Product Change Notification

Change Notification #: 115636 - 00
Change Title: Intel® Dual Band Wireless-N 7260,
Product Code 7260.NGWG.NV,
PCN 115636-00, Label,
SKU Re-activation and Label Update
Date of Publication: June 27, 2017

Label

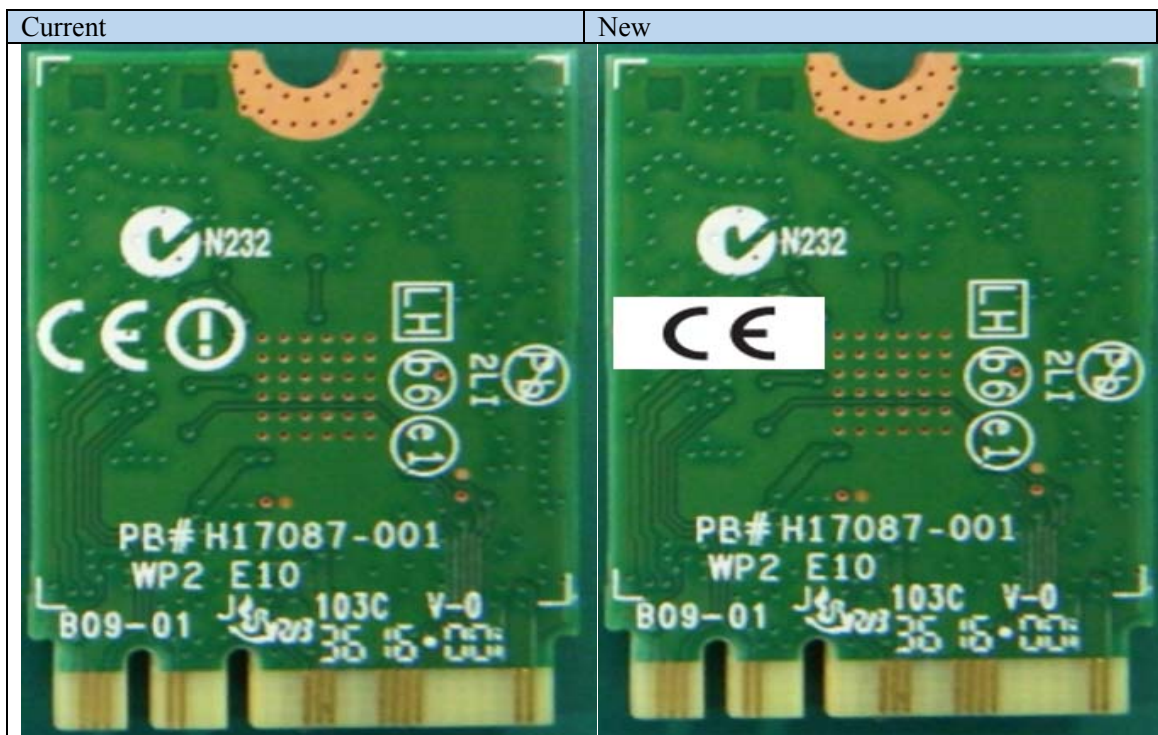
A selected SKU in the Intel® Dual Band Wireless-AC 7260 product family has been re-activated to accommodate a last time buy. As a result, we will be updating the SKU to be compliant with the new European Radio Equipment Directive 2014/53/EU. Please review changes below:

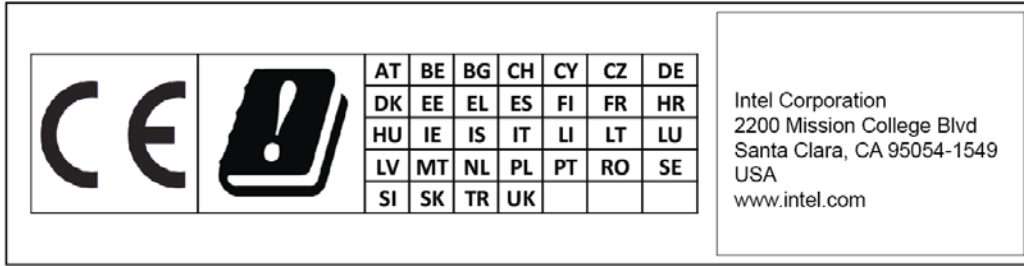
1. The current CE ! Mark on the module will be modified to remove the Alert Symbol (!) following the CE mark. Example of CE mark change on PCB artwork:

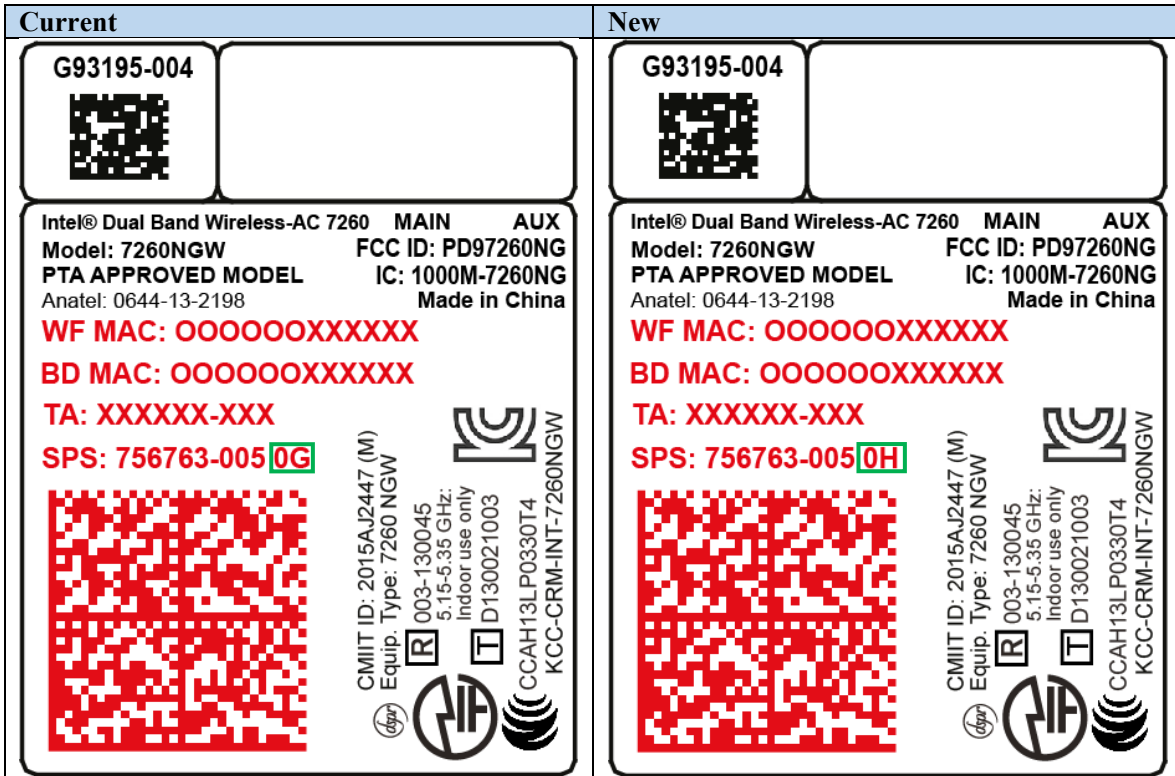
3. Updating revision number on internal tracking #:

SKU	Current	New
7260.NG.WG.NV	0G	0H
